Be Careful What You Wish For: How a Four-Lane Mass. Ave. Would Eliminate Parking and Harm Businesses in East Arlington

A Study By the East Arlington Livable Streets Coalition

Figure 1: Project opponents’ vision for four lanes plus extra-wide parking and travel lanes leaves no room for parking on one side of the street.

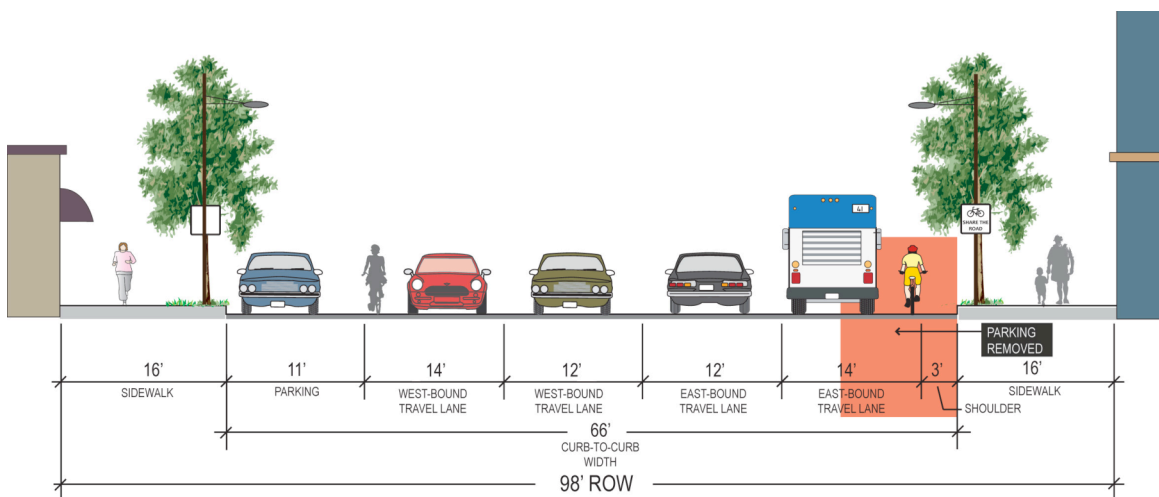
By itself, the demand for four traffic lanes with extra-wide parking lanes translates into a 72-foot profile for a four-lane Mass. Ave. consisting of:

- two standard-width 11-foot travel lanes, one east-bound and one west-bound;
- two 14-foot shared travel lanes, east and west;
- two 11-foot parking lanes, east and west.

The only way to fit these demands into the 66-foot dimension is to eliminate a parking lane along one side of Mass Ave from end to end.

While project opponents do not say what widths they prefer, adding 1 foot to 11-foot-wide lanes would bring the cross section to 74 feet—8 feet more than the standard 66-foot width today. Curb-side parking on one side of the street would need to be removed to fit four travel lanes within the 66-foot-wide sections of Mass Ave; see Figure 1 below.
